Project	IEEE 802.16 Broadband Wireless Access Working Group < http://ieee802.org/16 >	
Title	Sleep Mode in MR network	
Date Submitted	2007-01-15	
Source(s)	Yuefeng Zhou; Mike Hart; Sunil Vadgama Fujitsu Laboratories of Europe Ltd Hayes Park Central, Hayes End Road, Hayes, Middlesex, UB4 8FE, UK	Voice: +44 (0) 20 8573 4444 FAX: +44 (0) 20 8606 4539 Email: Yuefeng.zhou@uk.fujitsu.com Mike.hart@uk.fujitsu.com Sunil.vadgama@uk.fujitsu.com
	Keiichi Nakatsugawa, Masato Okuda Fujitsu Laboratories Ltd. Kamikodanaka 4-1-1, Kawasaki, 211-8588, Japan	Voice: +81-44-754-2811 Fax: +81-44-754-2786 nakatsugawa@jp.fujitsu.com okuda@jp.fujitsu.com
	Shiao-Li Tsao, Fang-Ching Ren, Wern-Ho Sheen, I-Kang Fu National Chiao Tung University (NCTU) /Industrial Technology Research Institute (ITRI), Taiwan No. 195, Sec. 4, Chung Hsing Rd., Chutung, Hsinchu, Taiwan 310, R.O.C.	Voice: +886-3-5712121-54717 Fax: +886-3-5721490 E-mail: sltsao@cs.nctu.edu.tw , frank_ren@itri.org.tw

MS Sleep Mode in MR network

Figure XX – MR-BS approves of CIDs entering sleep mode

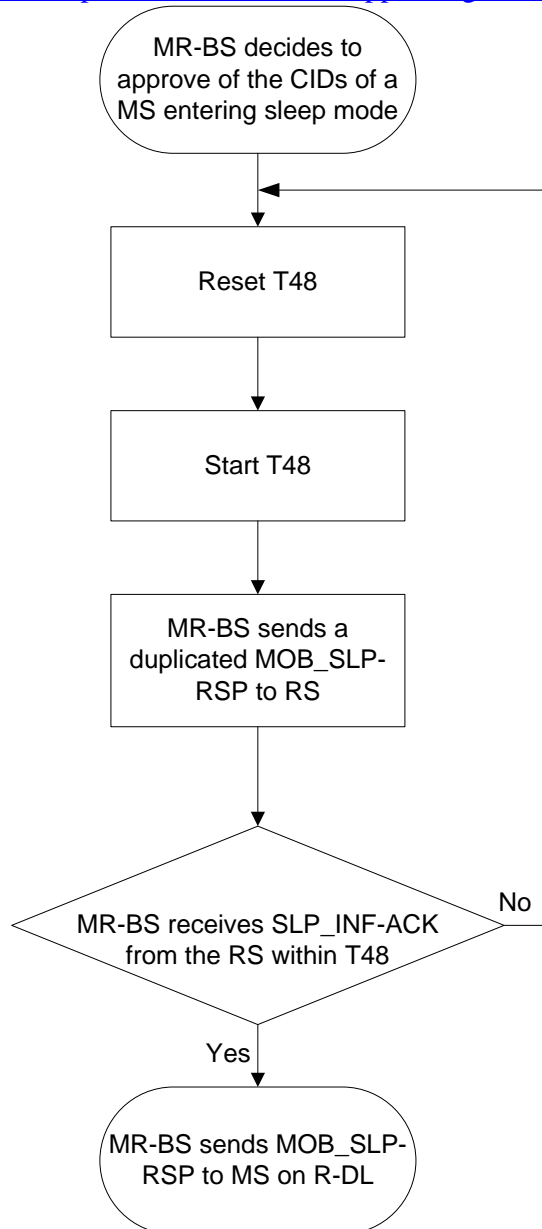
In the distributed scheduling case, the MR-BS shall firstly send a duplicated MOB_SLP-RSP message to the RS on the RS’s basic CID. After receive the duplicated MOB_SLP-RSP message, the RS shall

send SLP_INF-ACK message to MR-BS to acknowledge that it got the information about the sleep context of the CIDs indicated. The MR-BS shall retransmit the duplicated MOB_SLP-RSP message to the RS on the RS's basic CID, if it does not receive the SLP_INF-ACK message from the corresponding RS within the T48 timer. Once MR-BS receives the SLP_INF-ACK message, it shall send a MOB_SLP-RSP message, which will be relayed by RSs, either in response to a MOB_SLP-REQ or unsolicited. Fig. XX illustrates the procedure of MR-BS approving of sleep-mode CIDs.
